**GPU Nuclear Corporation**  
Post Office Box 388  
Route 9 South  
Forked River, New Jersey 08731-0388  
609 971-4000  
Writer's Direct Dial Number:

October 18, 1985

Subject: Oyster Creek Nuclear Generating Station  
Docket No. 50-279  
Technical Specification Change Request No. 142

**LO-LO WATER LEVEL TUBING & CONTROL LOGIC SET-UP**

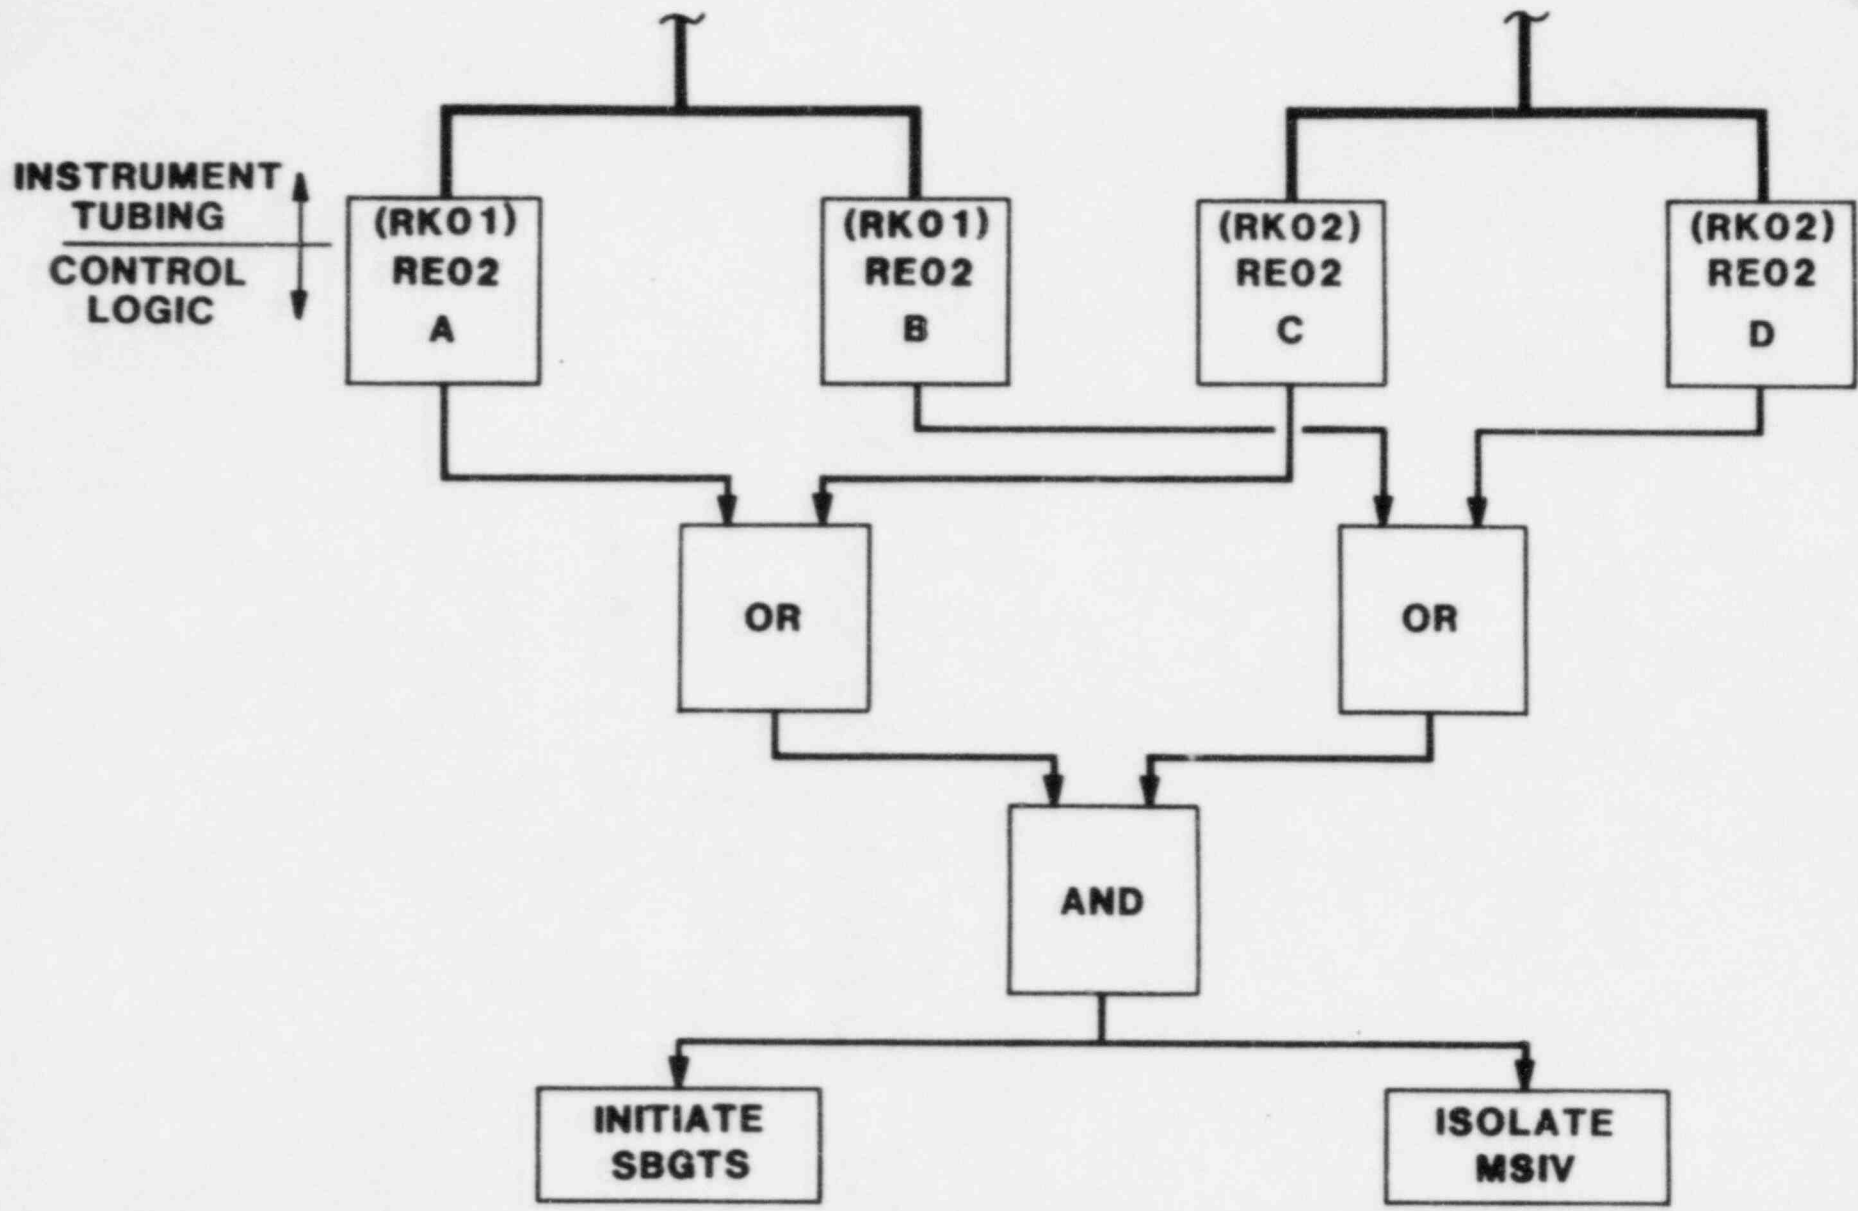
It was also requested that we discuss in greater detail why both trip systems must be made inoperable in order to accomplish the modification.

The LOW-LOW Reactor Water Level instrumentation hydraulic and control logic is shown in the attached sketch.

RE02A through D are the instruments that change state when the reactor water level reaches the LOW-LOW setpoint. RE02A&B, located on RK01, share a common header with RE05A and RE05/19A. RE02C&D, located on RK02 share another common header with RE05B and RE05/19B. RE02A and C input to control logic channel 1 and RE02B and D input to control logic channel 2.

The EQ modification scheduled for the upcoming outage will replace the RE02's, RE05's and RE05/19's with the new Environmentally Qualified transmitter switches. The modification will replace RE02's one for one. RE05's will be replaced by two switches each, and RE05/19's will be replaced by one transmitter and two switches each. To accomplish this the tubing will be cut upstream of the existing valve manifolds. Therefore, the manifolds cannot be used for isolating the instruments.

Technical Specifications (Table 3.1.1, Item J.4) require at least one complete trip channel to be operable during shutdown. Because of the tubing layout of the level monitoring instruments, it is necessary that one instrument out of each trip channel be disabled to accomplish the modification. Therefore, a complete channel cannot be maintained operable during the modification.
